Preliminary Staff Assessment

BEACON SOLAR ENERGY PROJECT

Application For Certification (08-AFC-2)
Kern County

APRIL 2009
(08-AFC-2)
CEC-700-2009-005-PSA

Soil & Water Figure-C4
Cross section comparison
Peak flow capacity estimated

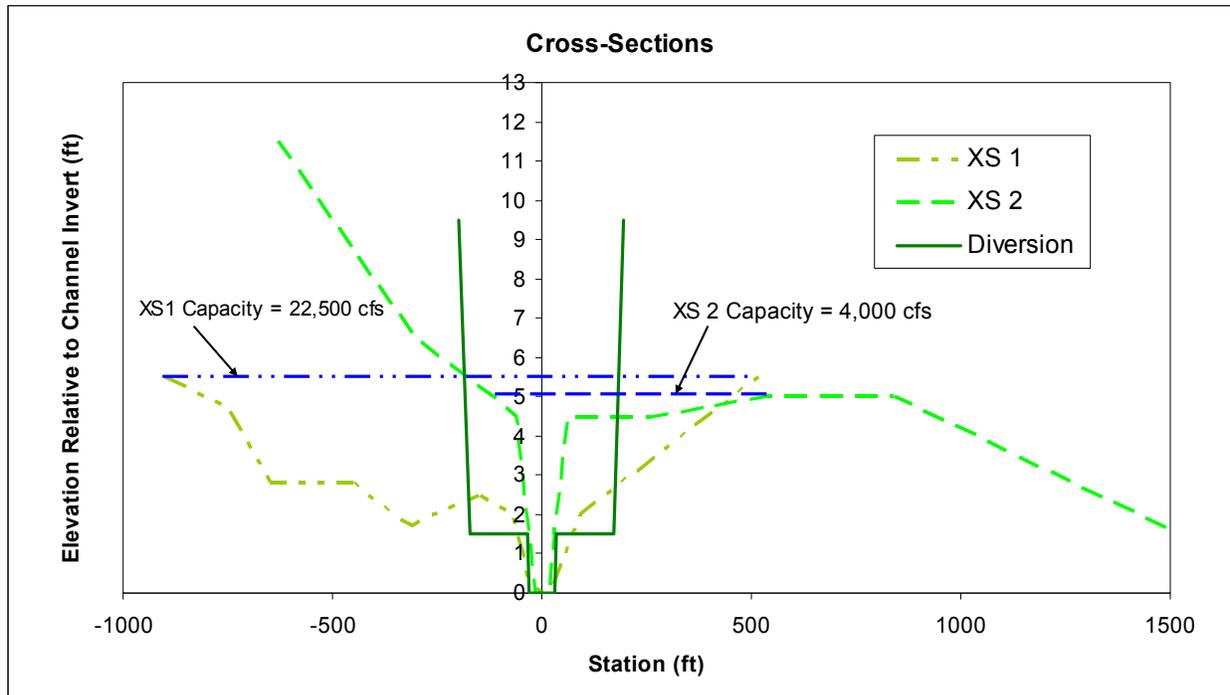
Cross section 1 (XS 1), was cut from the recommended reference reach shown on **Soil & Water Figure-C3**. The main active channel (or low flow channel) for XS 1 has an approximate capacity of 877 cfs, which matches the region's Hybrid Regional Regression results (West, 2007) for the 5-year event. A second cross section was located on the southern property line, XS 2, to examine the channel capacity at property line and for staff to understand the change in cross sectional area between the natural channel and the diversion channel. According to staff's estimates, the approximate capacity of the channel at the property line is approximately 4,000 cfs. Flows greater than the channel capacity would sheet flow out of bank to the east. The overbank flow would likely continue to flow overland toward the proposed diversion channel but would not enter the channel at point of diversion where BSEP has planned to armor the channel. **Soil & Water Figure-C4** illustrates the reference reach (XS 1) and its capacity, the channel at the property line (XS 2) and its capacity and the diversion channel.

The proposed diversion channel as designed by BSEP would have some degree of natural geomorphic function, including a limited ability to braid, meander and laterally migrate. Staff has assessed the potential for the proposed diversion channel to migrate laterally and have considered the potential for the channel to downcut. Staff has determined that for the protection against the possibility that the channel would migrate towards and erode a section of the channel bank, bank toes would require adequate stabilization. Staff also anticipates that the channel, as designed, is not adequately stable for the design flood.

**Soil & Water Figure-C5
Staff Hydraulic Model – Velocity Profile**

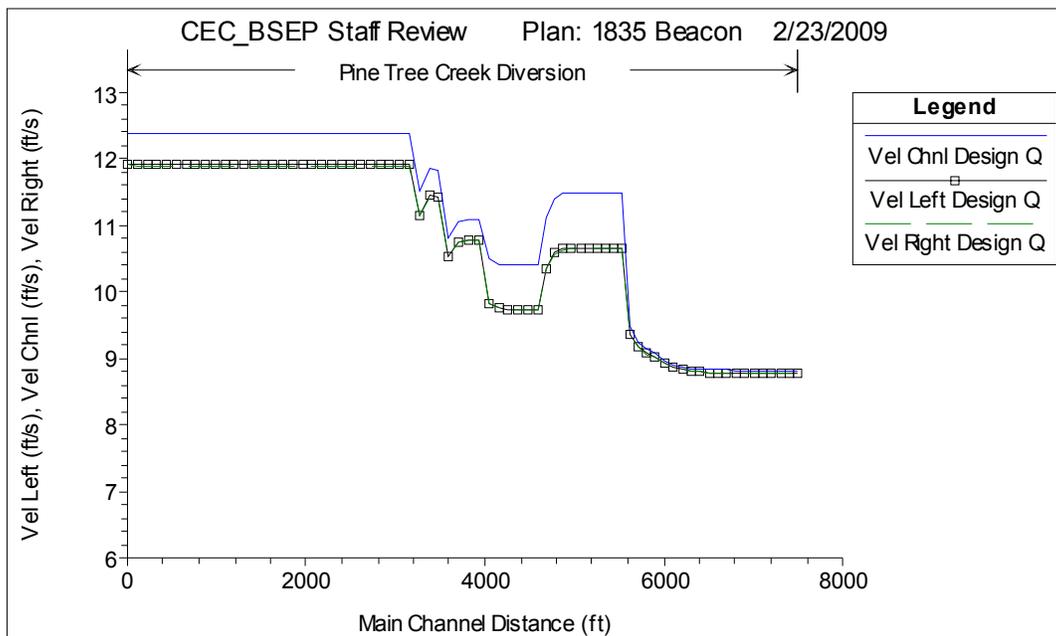
The results of staff’s analyses are shown graphically in the following figures. **Soil & Water Figure-C5** presents the results of the velocity for flow in the main channel (low flow) and flow in the overbank or floodplain areas. The low flow channel dimensions, from the BSEP design, define the channel width. The resulting velocities vary throughout the study reach. Velocities are lower at the upper end of the channel where the slope is less steep at 0.5%. Velocities throughout the study reach are well above typical design velocities for natural earthen channels of 5 to 6 fps.

Soil & Water Figure-C6
Staff Hydraulic Model – Hydraulic Depth Profile

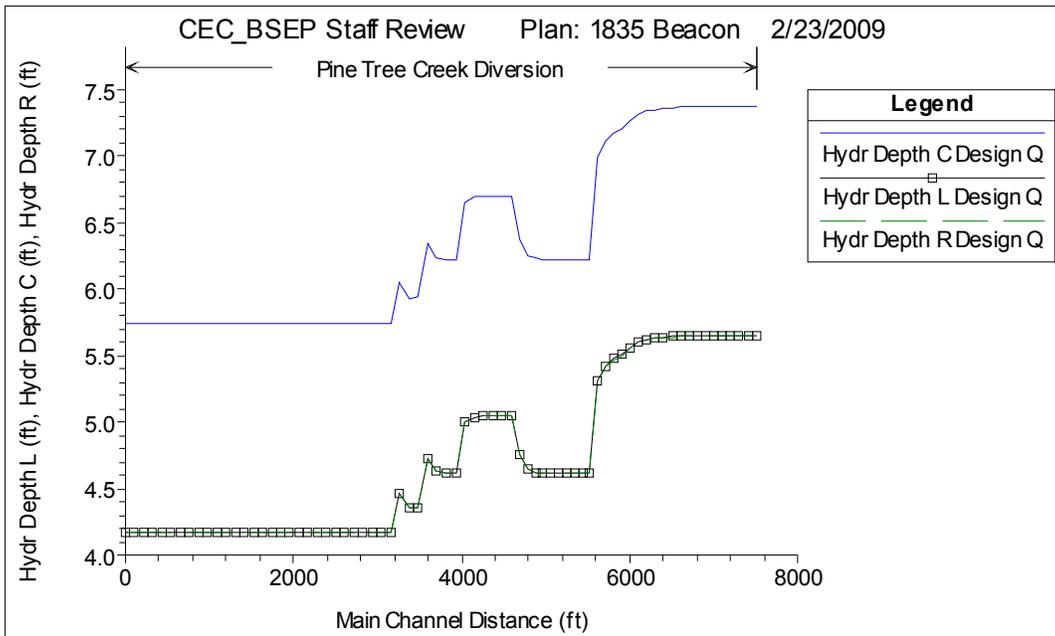
Soil & Water Figure-C6 shows the results of the hydraulic depth for flow in the main channel and depths in the right and left overbank areas. Greater depths of flow require greater excavation depth or may require levees to contain the design flood.

Soil & Water Figure-C7
Staff Hydraulic Model – Shear Stress Profile

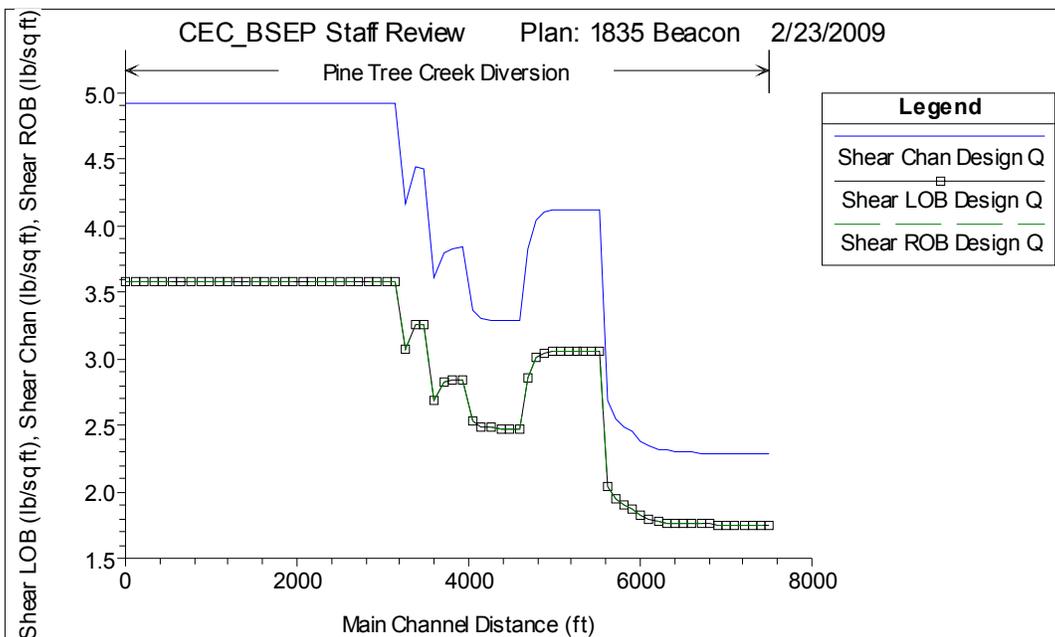
Soil & Water Figure-C7 shows the results of the shear along the channel and overbanks of the study reach. These shear stress results are particularly high in the steep reach of the channel. High shear typically requires bank treatments to protect the banks from erosion and failure. Staff examined several bank and channel treatments in the PSA and have specified typical ranges of allowable shear stress for each. To reduce the need for structural bank treatments, staff recommends that the shear stress in the study reach be reduced.

Soil & Water Figure-C9

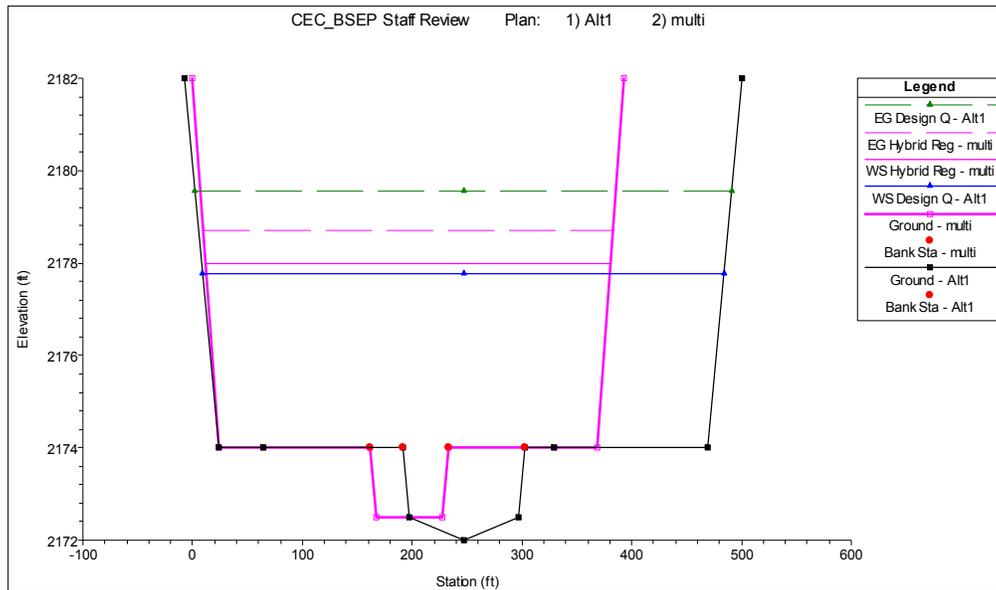
Soil & Water Figure-C9 provides a comparison of two cross sections located at the upper end of the study reach. The alternative model cross section width was increased a nominal 100 feet and the low flow channel was slightly deepened and widened.

Soil & Water Figure-C10

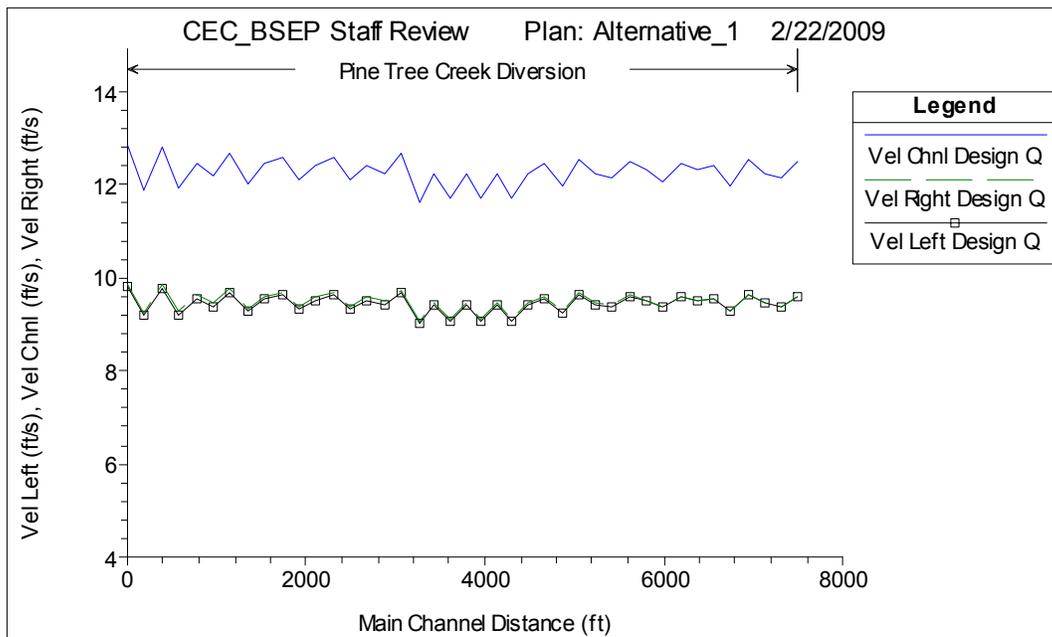
The velocity results of Staff's alternative analyses are shown graphically in **Soil & Water Figure-C10**. Results from this analyses are more uniform owing to the continuous cross sectional shape and channel slope. Velocities remain well above typical design velocities for natural earthen channels of 5 to 6 fps.

Soil & Water Figure-C11
Staff Alternative 1 – Hydraulic Depth Profile

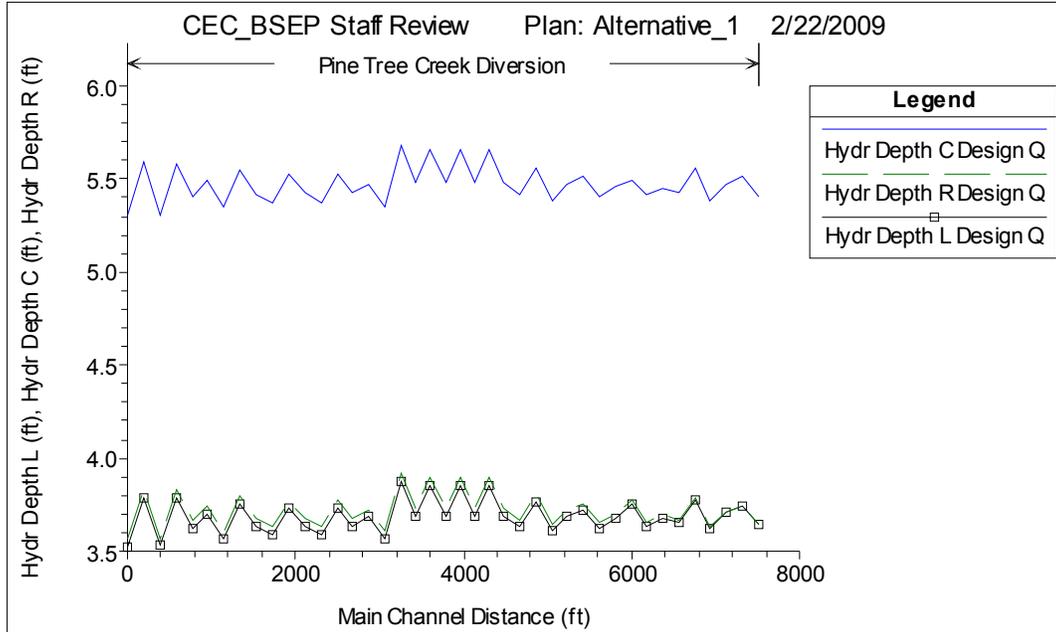
The hydraulic depth results are shown in **Soil & Water Figure-C11** below. These depths are more typical of natural channel and floodplain characteristics. The widened channel provides a more significant flow path which results in slightly lower water levels.

Soil & Water Figure-C12
Staff Alternative 1 – Shear Stress Profile

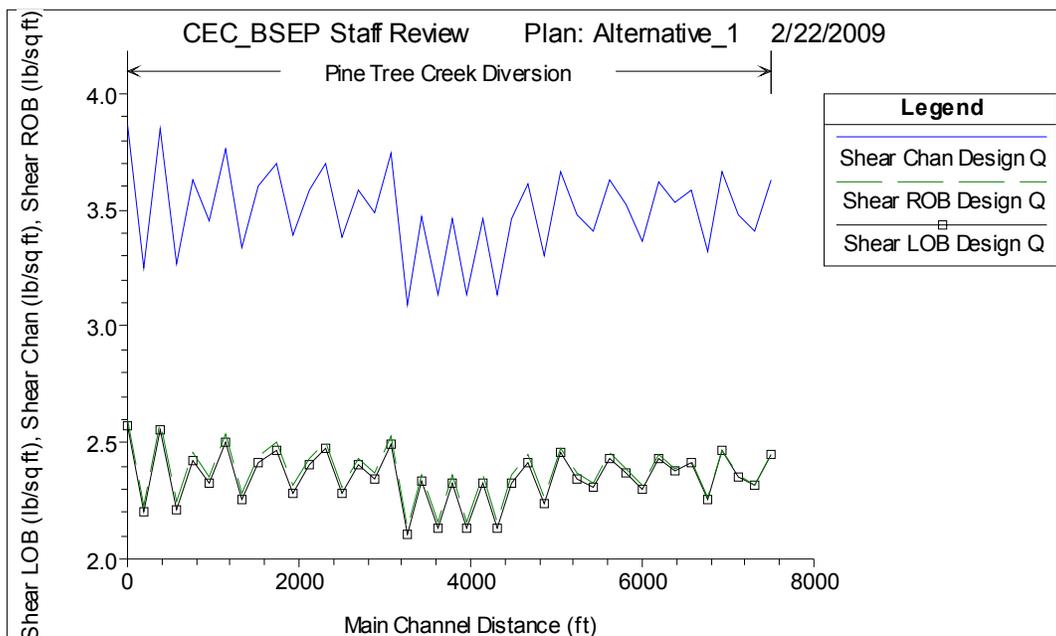
Soil & Water Figure-C12 presents the shear stress results for the alternative study reach. As anticipated the shear stress was more consistent throughout the channel when the slope was maintained as a constant.

Soil & Water Figure-C13
Staff Alternative 1 – Froude Number Profile

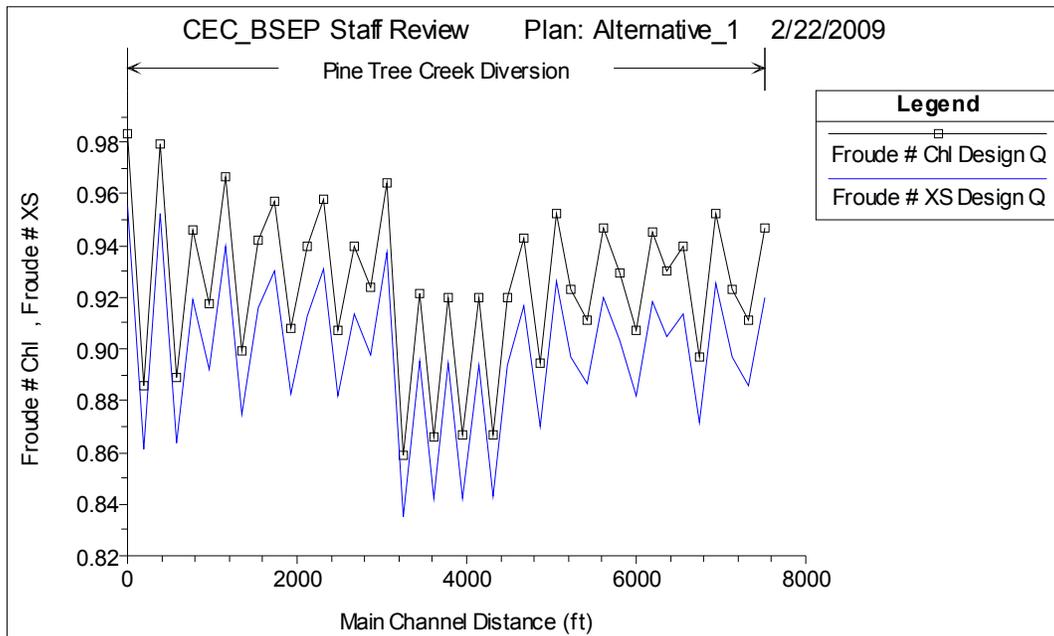
Finally, the Froude Numbers are presented in **Soil & Water Figure-C13** below. These Froude Numbers remain above the 0.80 target signally a need to reduce the velocity.
